33512B-02

# Modification Recommended Service Note

## 33512B Function Generator

Serial Numbers: MY000000000 to MY57400600 and SG000000000 to SG57400600

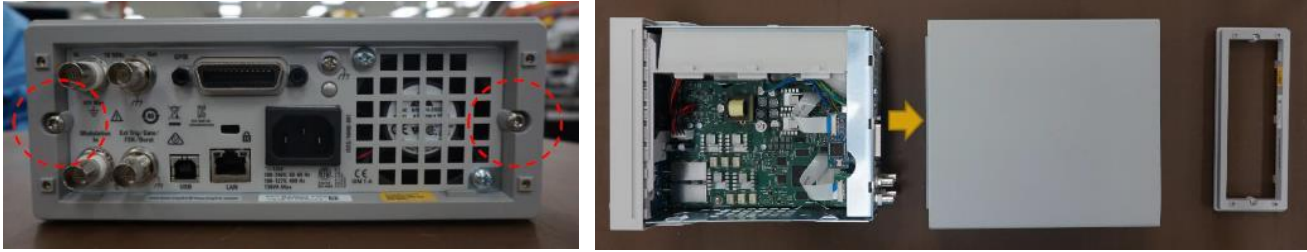
**The Problem** – Some customers have reported that, when line power is applied to the instrument but the instrument is NOT turned on (“Standby Mode”), some instruments will emit an audible high-pitched whistle or whine. To fix this, the existing power supply must be replaced with a newly designed power supply, as detailed in the solution below.

The solution is to replace the old power supply with a new one. The old power supply was manufactured by XP Power. The new power supply is manufactured by MeanWell, and has Part Number 0950-6082.

**Old Noisy XP Power Supply (PN xxxx-xxxx)**

**New MeanWell Power Supply (PN 0950-6082)**
